January 15, 2018

## MEMORANDUM

**Subject: Review of Groundwater Conditions**  
**Ash Pond D at the Possum Point Power Station**  
**Project No.: 019-08**

## Possom Point Power Station Site Plan

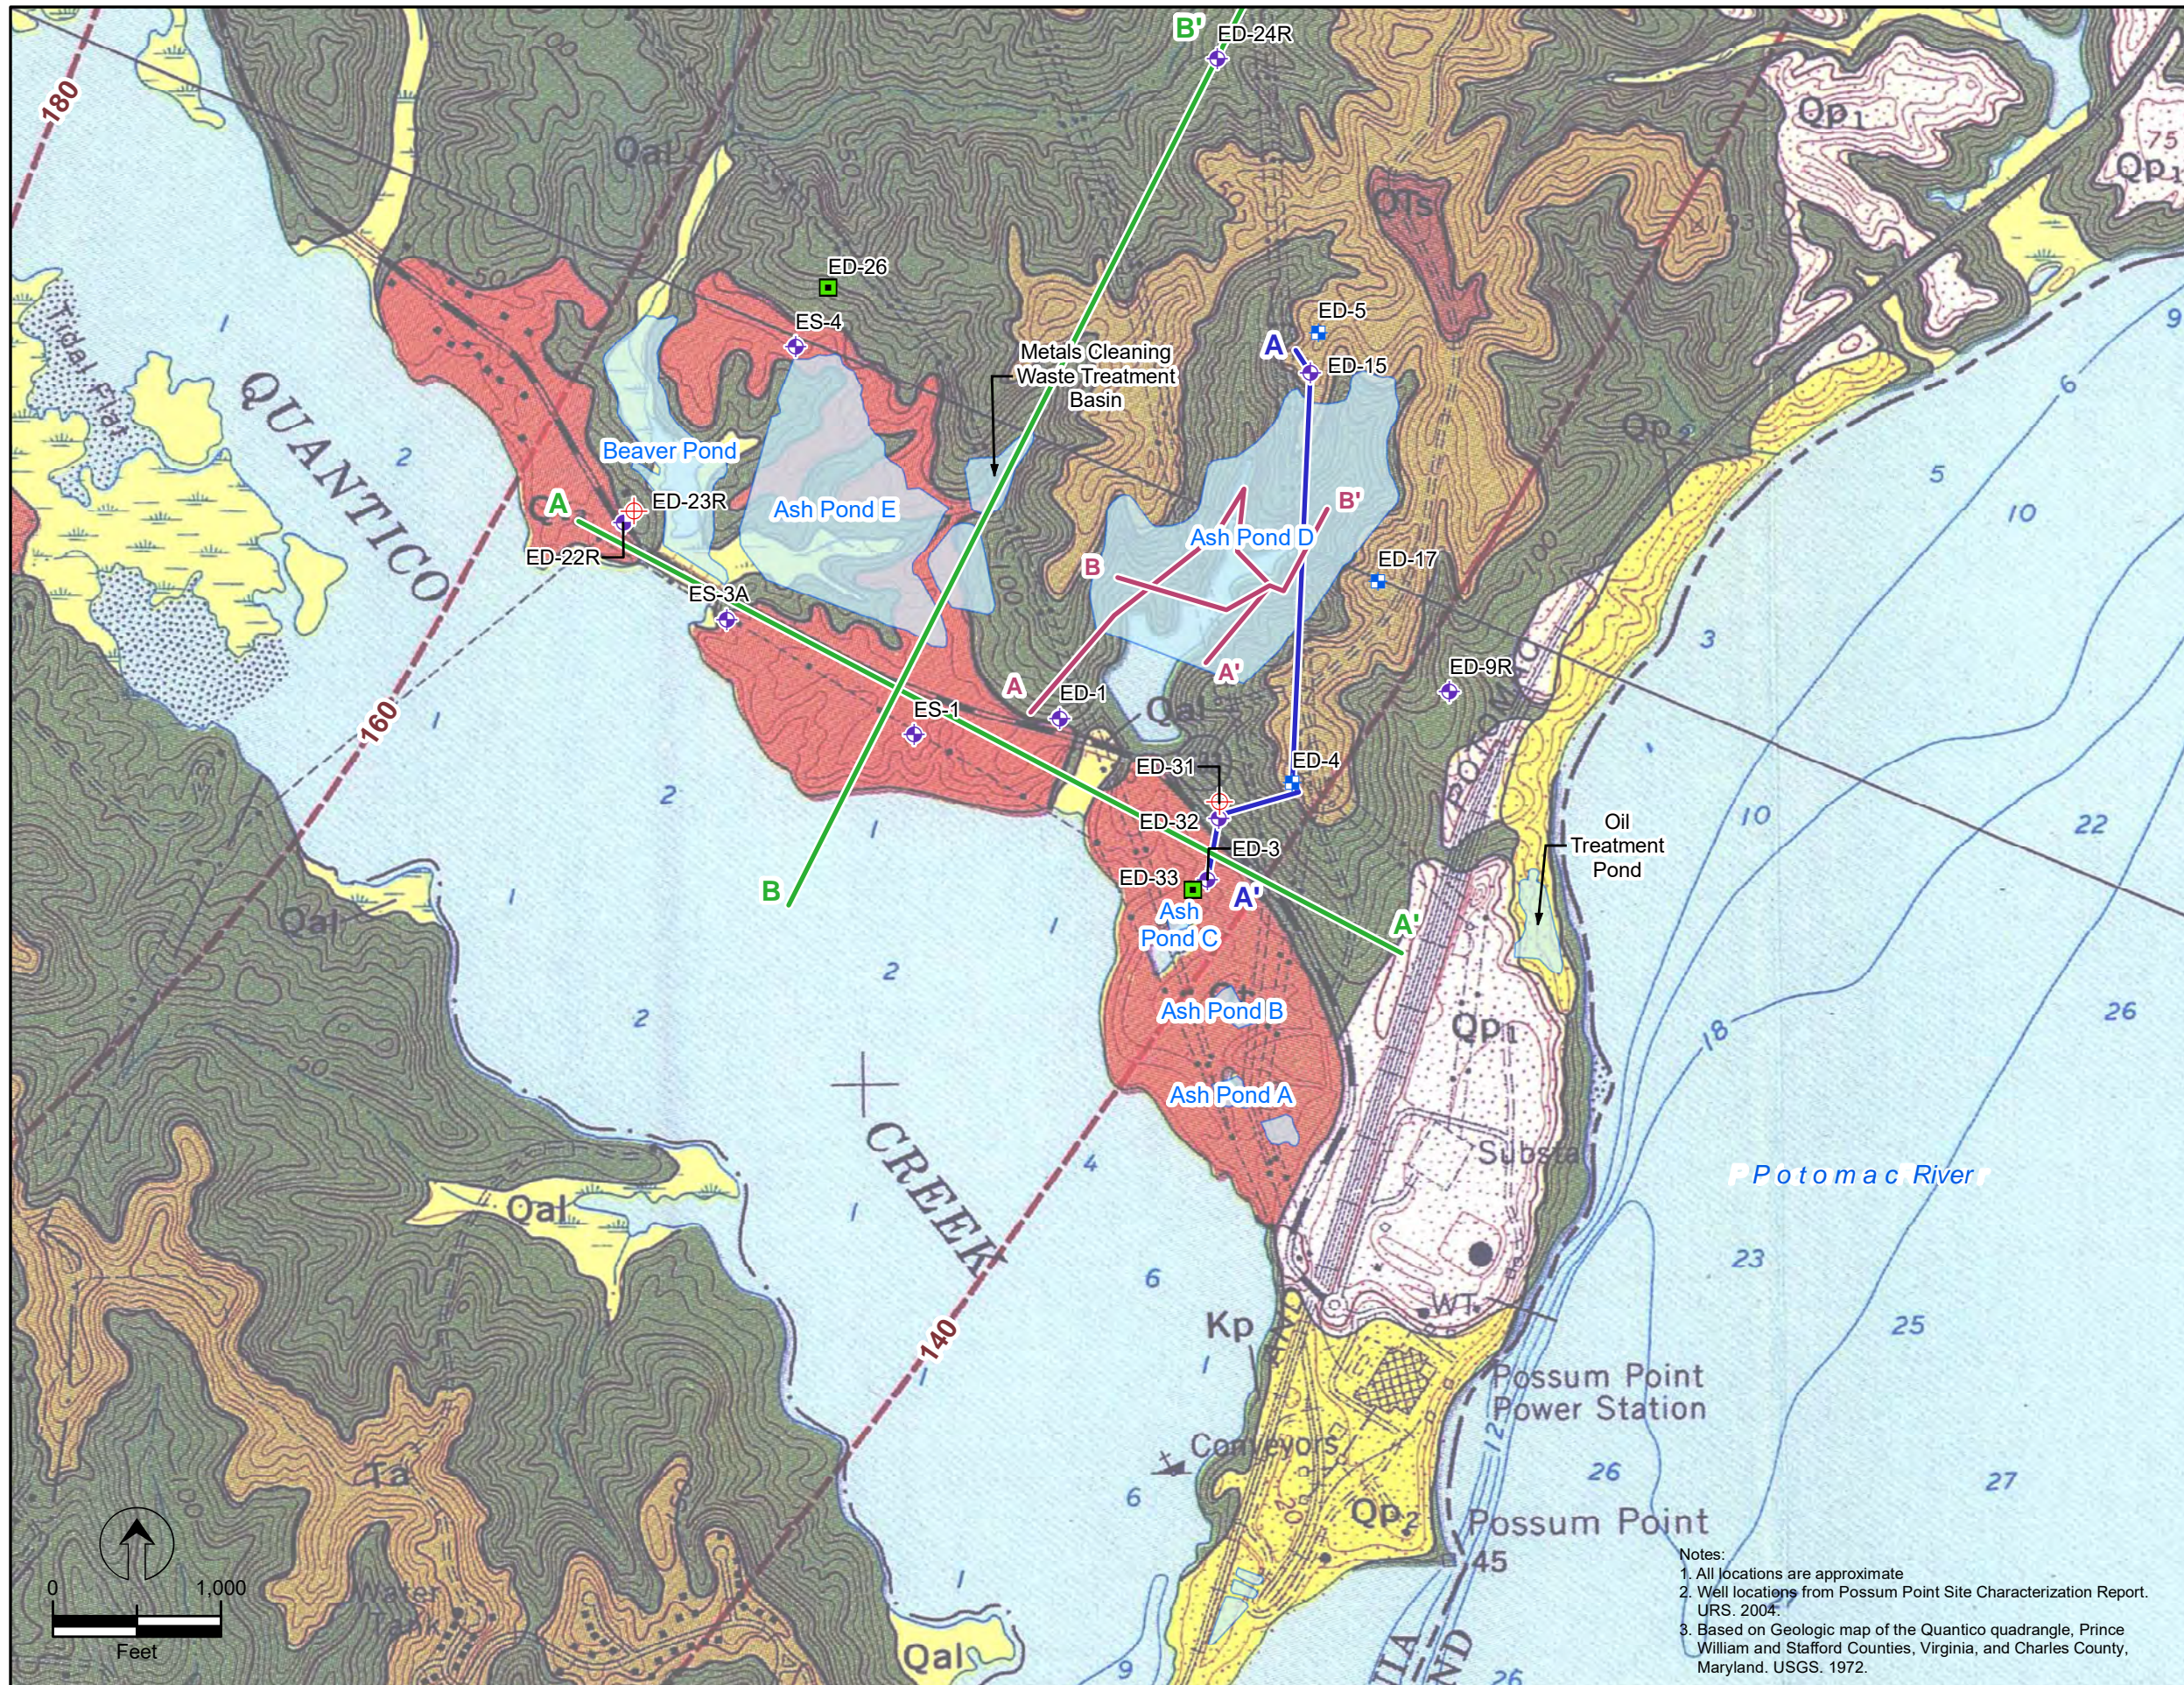
Yes. As shown in **Figure 2**, standing water is ponded on the southern part of Ash Pond D adjacent to the dam. This ponded water is in direct contact with coal ash waste and is in direct hydrologic connection with the underlying groundwater in the coal ash waste. Therefore, surface water in the Ash Pond D is in direct contact with coal ash waste.

MSL based on AECOM's Site Topography Figure TM6-10 (2017). Groundwater in close proximity to Ash Pond D is present at 31.41 to 43.62 feet above MSL (**Figure 2**). However, groundwater in Ash Pond D may be as high as 70 feet MSL, as indicated in AECOM's potentiometric figure (**Figure 2**).

In 2015 and 2016, many of the existing monitoring wells were destroyed as a result of excavation activities and new monitoring wells were installed. The new monitoring wells are depicted on **Figure 2**. Wells ED-1612, ED-24R, ABC-1602, and ED-26 are considered to represent background groundwater conditions at the Site. No dissolved metals were detected above background levels or MCLs in the 2016 and 2017 groundwater samples collected from these wells. Therefore, any concentration of a dissolved metal detected above these background concentrations in a groundwater sample collected from other monitoring wells at the Site would be indicative of contamination.

**Possum Point Site Geology**

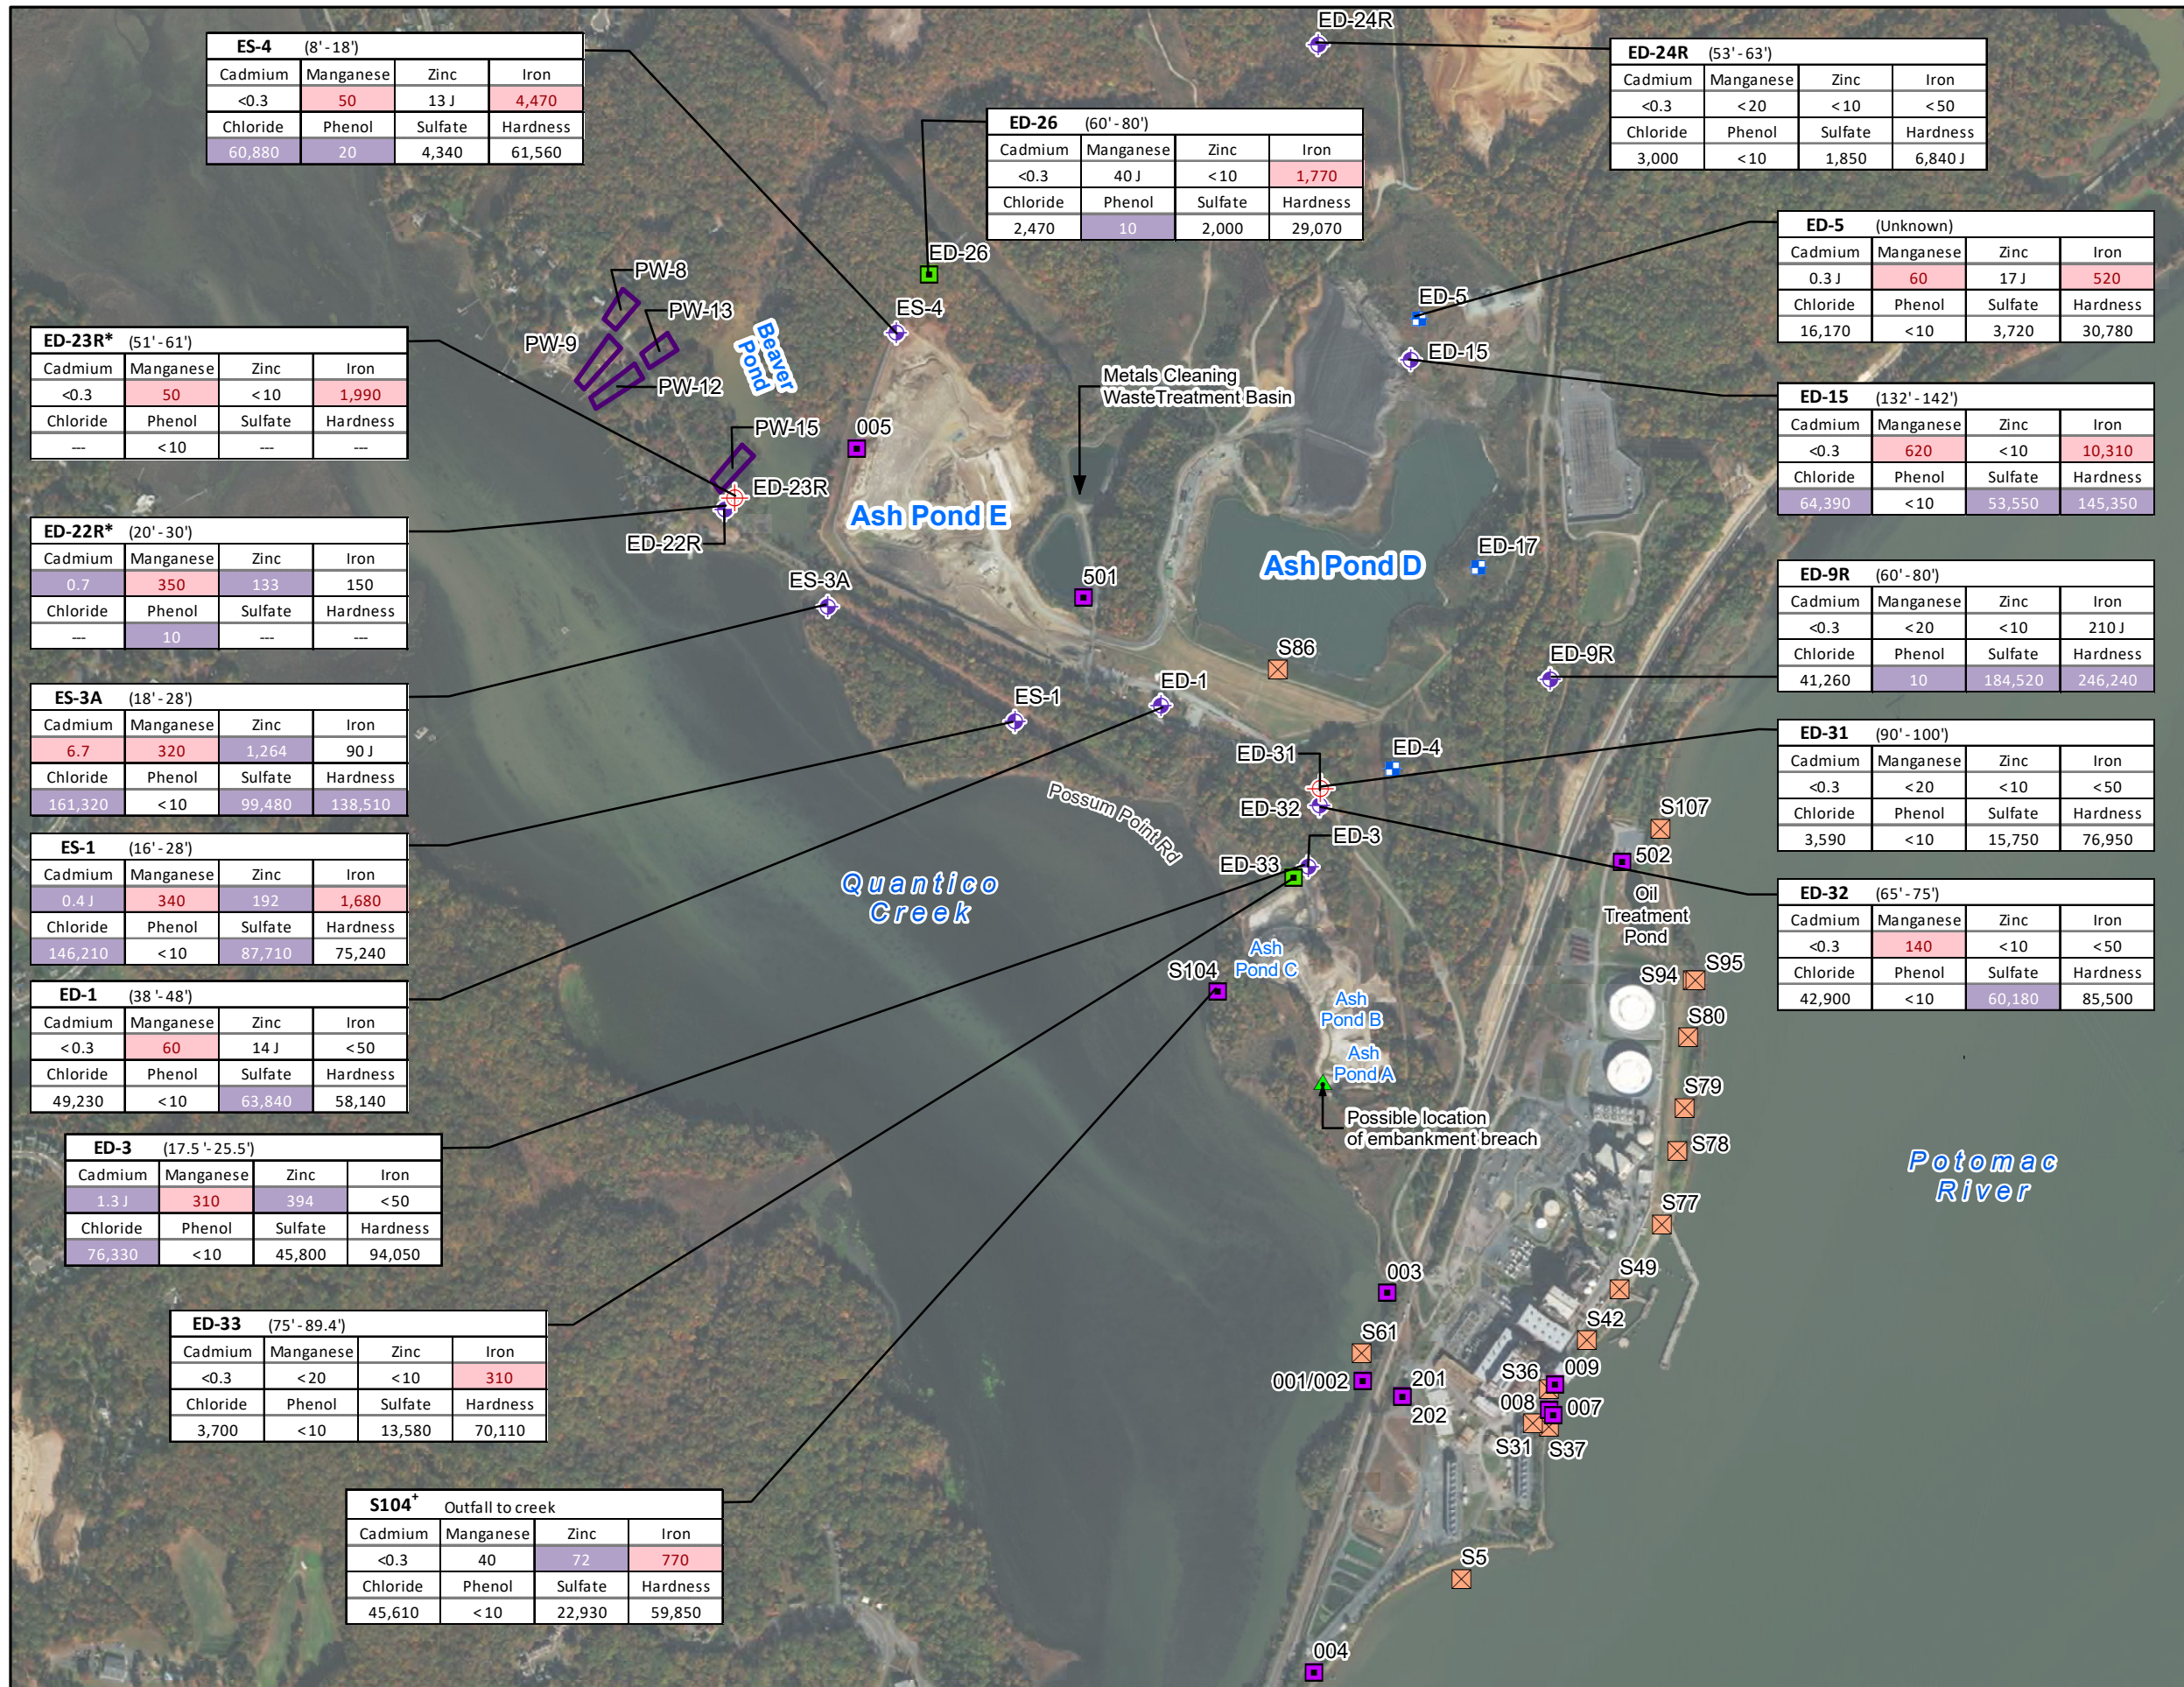
At Ash Ponds A, B, C, and E, coal ash waste has been placed within the Terrace Deposits in Stratum D (**Figure 3** and **Appendix A**). At Ash Pond D, coal ash waste has been placed within Strata C and D and directly above Strata E of the Potomac Formation (**Appendices B** and **C**). With ongoing recharge, groundwater elevations have risen, and groundwater is present within the coal ash waste. At Ash Ponds A, B, C, and E, coal ash waste was present between approximately 0 and 25 feet above MSL (**Appendix A**), and groundwater is present at approximately 3 to 25 feet above MSL (AECOM, 2017, **Figure 2**). There are currently no monitoring wells installed within the ash ponds, therefore the groundwater levels are based on both wells in close proximity to the ponds and the potentiometric surface created by AECOM (**Figure 2**). At Ash Pond D, coal ash waste prior to initiating closure activities was present between 0 and 60 feet above MSL (Appendix C). With additional coal ash being added to Ash Pond D, coal ash is likely present at elevations above 60 feet MSL, potentially as high as 100 feet
